PARTS & SERVICE	REF NO.	AT99155
NEWS	DATE	Nov. 1, 1999
		Page 1 of 6

SUBJECT: INTRODUCTION OF IMPROVED M-CLUTCH DISC OF TRANSMISSON ON 530M

PURPOSE: To introduce new M-clutch discs with improved wear resistance for use with the transmission assembly on 530M

APPLICATION: 530M Dump truck S/.N 32638, A30003 THRU A30035

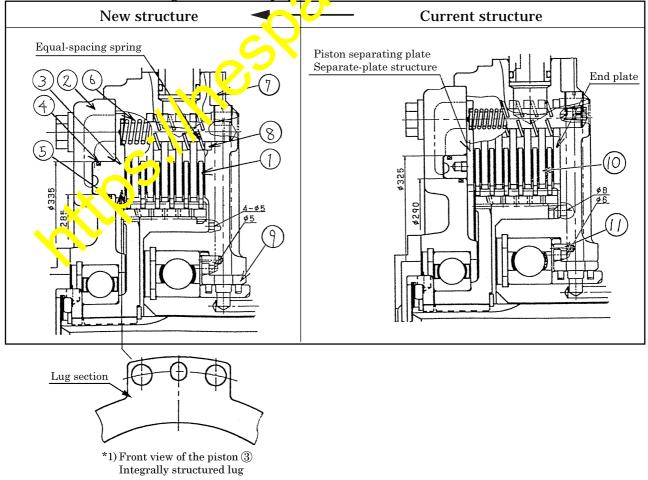
Although the part numbers of the pins Nos. 11, 12, 13 remain the same, prepare them as spare parts since they may not come off from the current housing "562-15-21180" or they may be damaged while removing from the current housing.

Housing ⑦ (When viewed from the input side of the transmission)

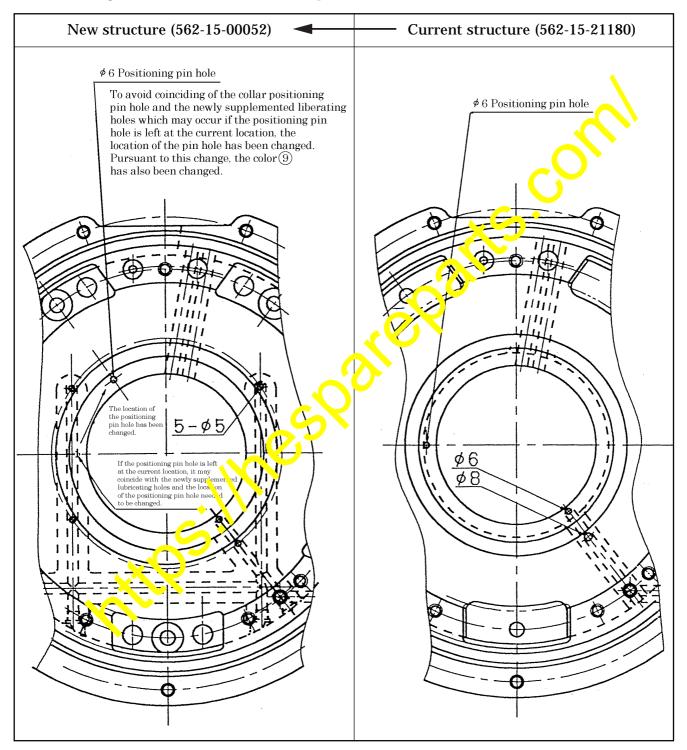
- 5) To improve the lubrication efficiency for the discs, the number of the lubricating holes in the housing ⑦ has been increased.
 - New structure: 5 ϕ 5 \leftarrow Current structure: $\phi + \phi \delta$

- 6) To avoid coinciding of the collar positioning pit hole and any of the newly supplemented lubricating holes which may occur atten the change of the lubricant circuit according to the above Paragraph 4), the location of the positioning pin hole in the collar

(9) has been changed. (Refer to page 2)

• Detail drawing for the changes according to Paragraphs 5) and 6) on page 3

*3) Torquflow ass'y: Transmission ass'y - 10 que converter ass'y *2) Identification methods for the new and current collars

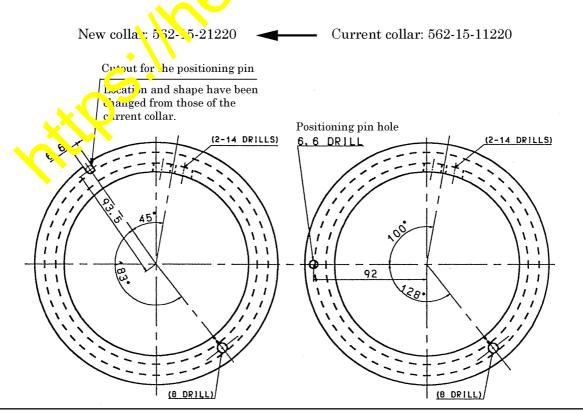
8	Plate	562-15-11260	5	O.D I.D ∮ 30 - ∮ 15, shape of a washer	XS	-	_
9	Collar	569-15-21220	1	*2): Refer to the drawing indicated be¦o.	562 15-11220	1	_
	Transmission Ass'y	562-15-21003	1		562-15-21002	1	_
	Torqflow Ass'y *3)	562-14-41003	1	As above improvements employed or machines under production, assemily part numbers have been changed.	562-14-41002	1
